RENESAS TECHNICAL UPDATE

Product Category	MPU/MCU		Document No.	TN-RZ*-A0108A/E	Rev.	1.00
Title	RZ/G2H and RZ/G2N Correction/Additional for Serial-ATA Gen3, SATA INT Status Register (SATAINTSTAT)	or 59.	Information Category	Technical Notification		
		Lot No.				
Applicable Product	RZ/G Series, 2nd Generation RZ/G2H RZ/G2N	All lots	Reference Document	RZ/G Series, 2nd Gen User's Manual: Hardw (R01UH0808EJ0110)		.10

Correction/Additional for 59. Serial-ATA Gen3, SATA INT Status Register (SATAINTSTAT).

59.2.31 SATA INT Status Register (SATAINTSTAT)

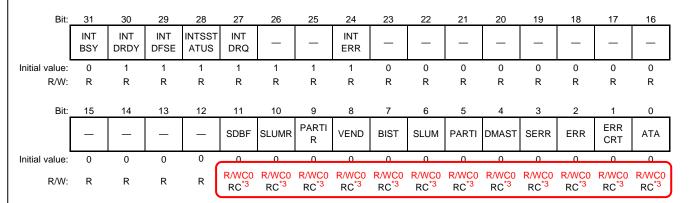
2. Section 59. Serial-ATA Gen3, Page 59-41 to 59-42, 59.2.31 SATA INT Status Register (SATAINTSTAT), Bit-11 to 0, R/W attributes are corrected.

Wrong descriptions for "R/W" of Bit [2:0] description table

Descriptions for "Notes" were added.

General Error Correction. (The contents of the 59.3.4 Interrupt Modes are not reflected to register explanation.)

Bit	Bit Name	Initial Value	R/W	Description
31	INTBSY	B'0	R	BSY bit
30	INTDRDY	B'1	R	DRDY bit
29	INTDFSE	B'1	R	DF/SE bit
28	INTSSTATUS	B'1	R	Definition varies with the command.
27	INTDRQ	B'1	R	DRQ bit.
26, 25	_	B'11	R	Reserved
				These bits are always read as 1.
24	INTERR	B'1	R	ERR/CHK bit
23 to12	_	All 0	R	Reserved
				These bits are always read as 0.
11	SDBF	B'0	R/WC0	Set Device Bits FIS reception
			RC*3	
10	SLUMR	B'0	R/WC0	A request for transition to the Slumber state has been received (for
			RC*3	device-initiated power management, i.e. DIPM).
9	PARTIR	B'0	R/WC0	A request for transition to the Partial state has been received (for
			RC*3	device-initiated power management, i.e. DIPM).
8	VEND	B'0	R/WC0	Vendor Specific FIS reception
			RC*3	
7	BIST	B'0	R/WC0	BIST Active FIS reception
			RC*3	
6	SLUM	B'0	R/WC0	Device rejects transition to Slumber Mode.
			RC*3	Refer to notes 2.

Correction (to):						
Bit	Bit Name	Initial Value	R/W	Description		
5	PARTI	B'0	R/WC0	Device rejects transition to Partial Mode.		
			RC ^{*3}	Refer to notes 2.		
4	DMAST	B'0	R/WC0	Same meaning as DMA Setup FIS reception (fpdma_req signal		
			RC ^{*3}	asserted)		
3	SERR	B'0	R/WC0	SCR SERROR register update		
			RC*3			
2	ERR	B'0	R/WC0	SCR SERROR register (SCRSERR) ERRE, ERRP, ERRC, ERRT,		
			RC ^{*3}	ERRM, and ERRI bits update		
1	ERRCRT	B'0	R/WC0	SCR SERROR register (SCRSERR) ERRE, ERRP, and ERRT bits		
			RC ^{*3}	update		
				Refer to notes 1.		
0	ATA	B'0	R/WC0	ATA source (equivalent to P-ATA's INTRQ)		
			RC ^{*3}

- 3. ISM in the ATAPI Control Register (ATAPI_CONTROL1) = 1 : R/WC0 ISM in the ATAPI Control Register (ATAPI_CONTROL1) = 0 : RC For details, refer to section 59.3.4, Interrupt Modes.
